28-Apr-2025 - Redlines - DD

Lot 39 - Duncans Creek  
697 Beacon Hill Road  
Lillington, NC 27546

# THE APEX - LH 'GEORGIAN'

FIRST FLOOR PLAN 'GEORGIAN'  
SCALE: 1/8"=1'-0" ON 11x17, 1/4"=1'-0" ON 22x34

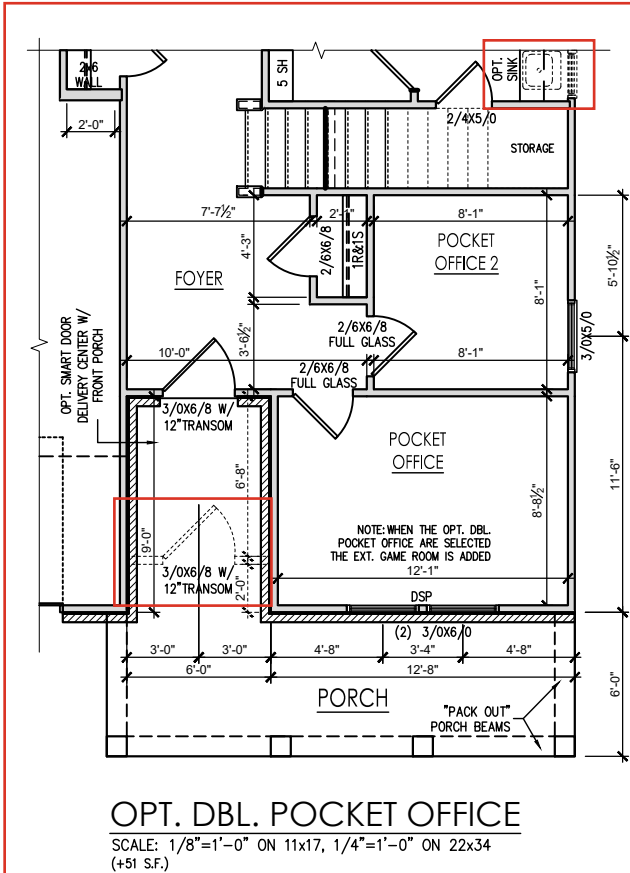
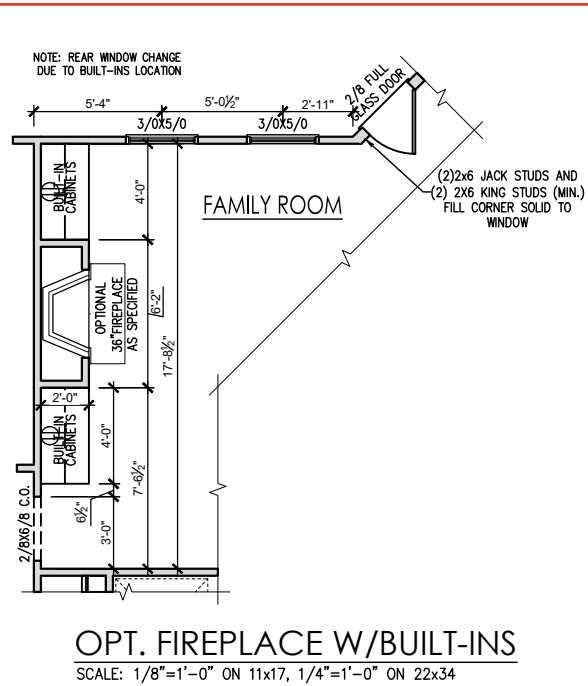
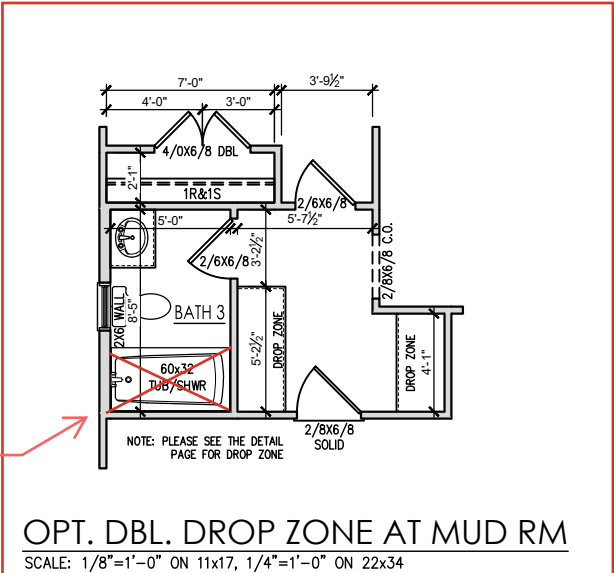
Shower ILO Tub/  
Shower

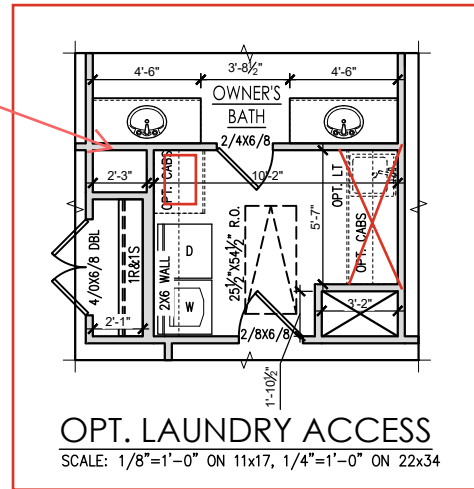
Free Standing Tub  
Next to W/D

SLAB FND. W/ SMART DELIVERY DR. W/ DBL POCK. OFFICE  
SCALE: 1/8"=1'-0" ON 11x17, 1/4"=1'-0" ON 22x34

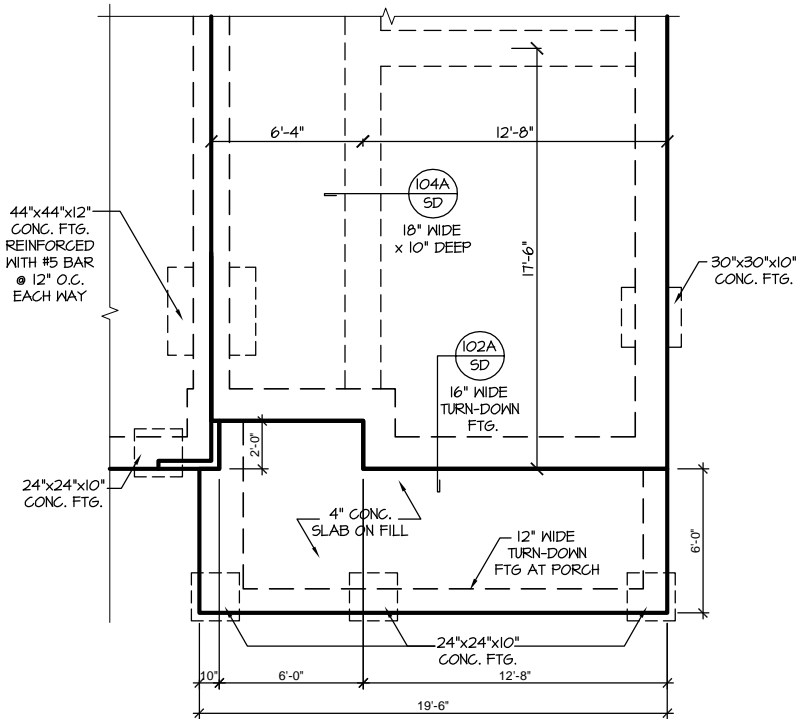
Shower ILO Tub/Shower

FIRST FLOOR PLAN 'GEORGIAN'  
SCALE: 1/8"=1'-0" ON 11x17, 1/4"=1'-0" ON 22x34

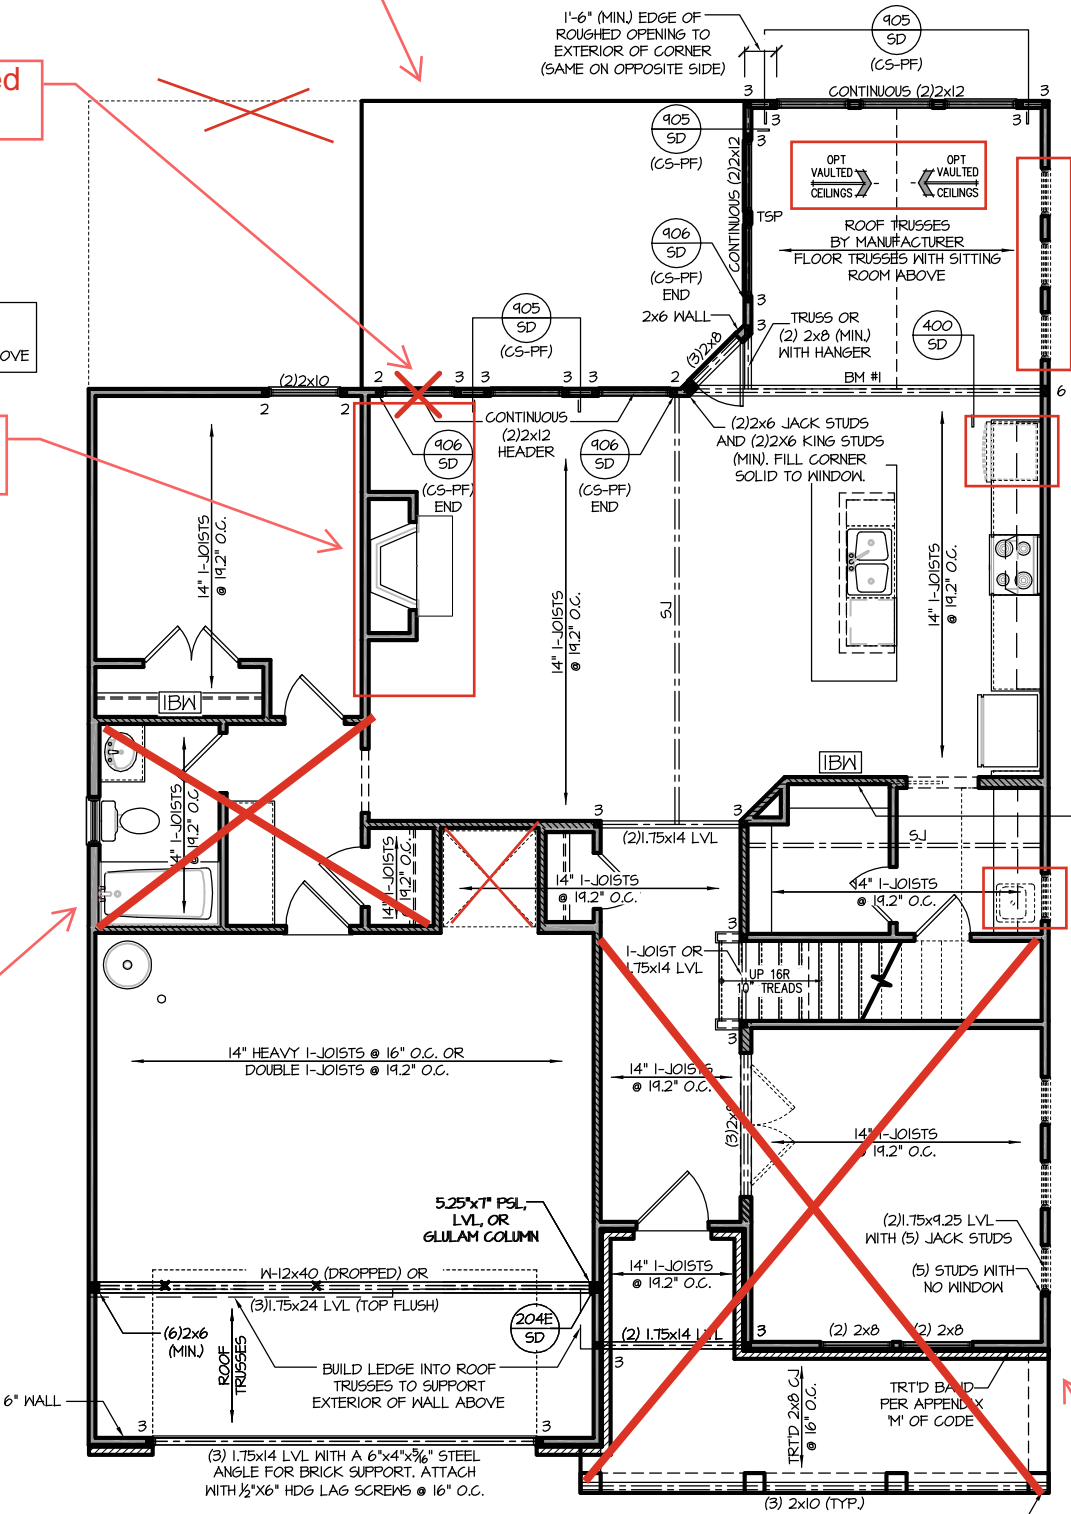
Window Removed  
Due to Built-Ins
